PRODUCT CHANGE NOTIFICATION

PCN: COMMONSense configuration interface

PCN #: 018-0530-24-1

Products Affected: Configuration interface for COMMONSENSE (FS.RSC.ACC.001-01 to FS.RSC.ACC.001-02)

FS.RSC.ACC.001-01 to FS.RSC.ACC.001-02

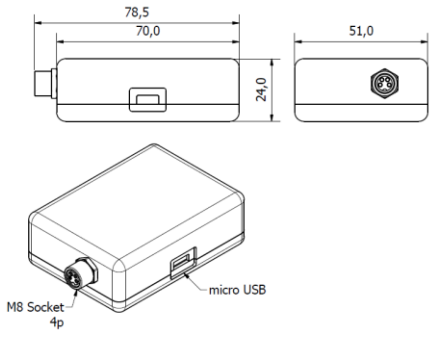
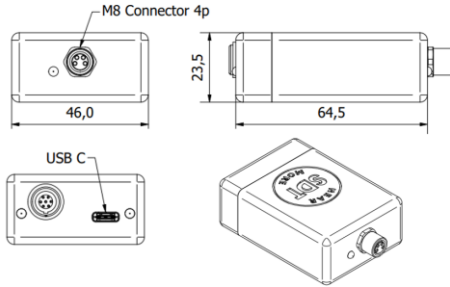
- Visual changes/ new housing + new PCB (better electrical noise insulation)/ Same features.
- Micro USB type to USB type C + LEMO 7 added.
- Both configuration box remain compatible with the SDT configuration tool (software).
- The new Recommended End User Price (REUP) is €375.

FU.RSC.ACC.001			
	<p>-01 : "Version 1" (discontinued)</p>		<p>-02: "Version 2" From SN 573 24 NNNN</p>
